U. S. NUCLEAR REGULATORY COMMISSION REGION I
OPERATOR LICENSING EXAMINATION REPORT

EXAMINATION REPORT NO. 50-309/85-13 (OL)

FACILITY: Maine Yankee

EXAMINATION DATES: May 14 to 16, 1985

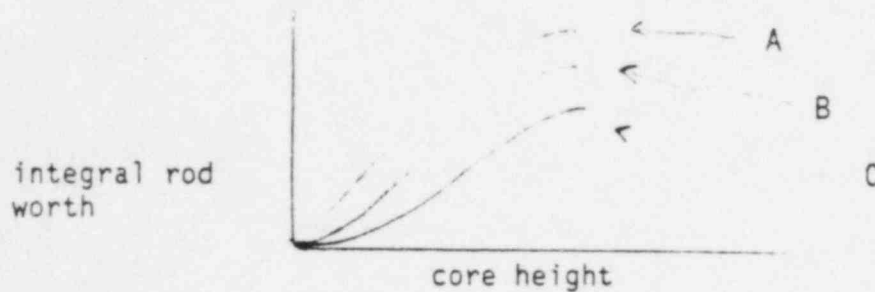
<u>Answer No.</u>	<u>Change</u>	<u>Reason</u>
5.3A	Add "immediate prompt drop to $P \sim \frac{\beta}{\beta - P} P_0$ or about 5% power".	Recognizes theoretical prompt drop in addition to concept of power level attributable to delayed neutrons.

immediate drop due to $\beta \approx \frac{\lambda}{\Lambda} \approx 5\%$

5. Concerning the Reactor Protection System.

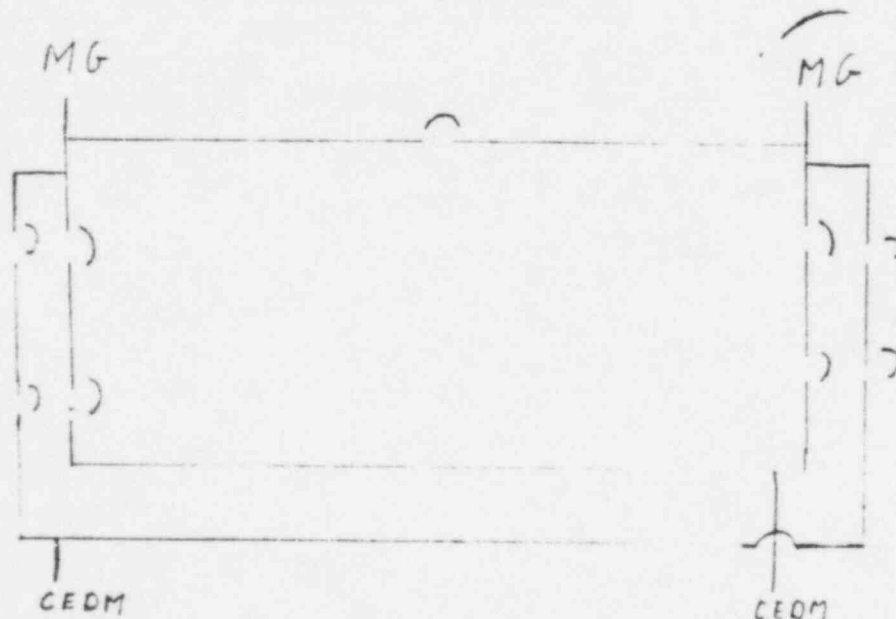
- A. Explain the main difference in operation between a shunt trip coil and an undervoltage coil in opening a reactor trip breaker. Which type is fail-safe and why? (1.5 pt)
- B. Using a one line diagram explain how the Maine Yankee reactor trip breaker arrangement prevents a partial reactor trip on the loss of a motor-generator set. (1.5 pt)
- ~~C. Which accident listed below will cause the non trippable control rods to drop into the core? (0.5 pt)~~
- ~~1) loss of coolant~~
 - ~~2) steam generator tube rupture~~
 - ~~3) loss of all offsite power~~
 - ~~4) steamline break~~
 - ~~5) main generator hydrogen explosion~~

- A. Undervoltage trip coils mechanically open the breaker when deenergized, (0.5 pt) shunt trip coils mechanically open the breaker when energized. (0.5 pt)

If the circled train is lost, the CEDM are still supplied by the other MG set. Both MG sets are full capacity MG sets.
